May 1, 2007

Re: BSA 74-07-BZ Congregation Shearith Israel 6-10 West 70th Street/99 Central Park West Block 1122 Lots 36. 37 - Manhattan

Figure 1 August 15, 2005 Section B 8 stories plus 2 penthouse

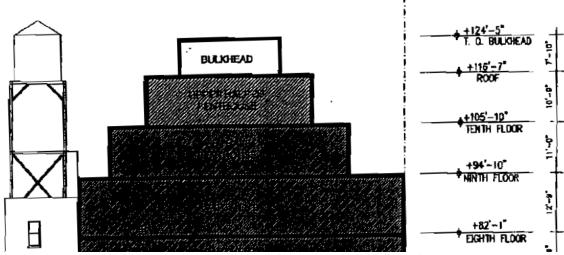
On August 15, 2005, the Congregation filed a new set of plans with LPC showing a building 124' 5" high:

What is curious is that the DOB objections dated October 28, 2005 refers to a building with maximum building height of 113.70 feet.

Yet, as shown above, the plans provided to LPC and Community Board 7 at that point in time, as shown above, reveal a 124.5 foot building. This is the proposal considered by the Community Board in September and October 2005 and on November 15, 2005 by LPC.

Figure 2 P-4 BSA Application April 2, 2007 8 stories plus 1 penthouse

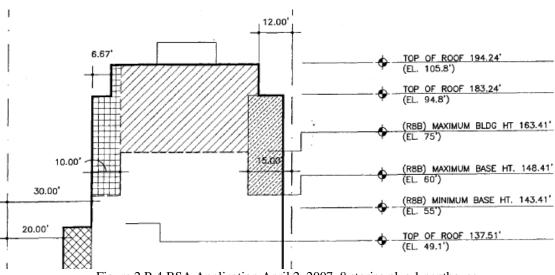
Above is an excerpt form the street wall section filed with BSA on April 2, 2007. There is a clear discrepancy – was the Congregation filing one set of plans in November 2005 with DOB, but presenting another set of plans later to LPC??

Moreover, the DOB objections number 3 and 7 are not consistent with either set of drawings.

- PROPOSED INITIAL SETBACK IN R8B DOES NOT COMPLY. 12.00' PROVIDED INSTEAD OF 15.00' CONTRARY TO SECTION 23-633.
- 7. PROPOSED REAR SETBACK IN R8B DOES NOT COMPLY. 6.67 PROVIDED INSTEAD OF 10.00 CONTRARY TO SECTION 23-663.

Quite clearly, the rear setback shown from floor 5-7 is not 6.67 feet, but is no setback at all (because the Congregation failed to provide required cross-sections with the floor heights, it is not simple to determine the floor.) The same discrepancy exists as to the initial setback – there is no initial setback until 94.8 feet. These are significant discrepancies, one that should have been noticed by the Congregation when discussing its proposal with DOB.
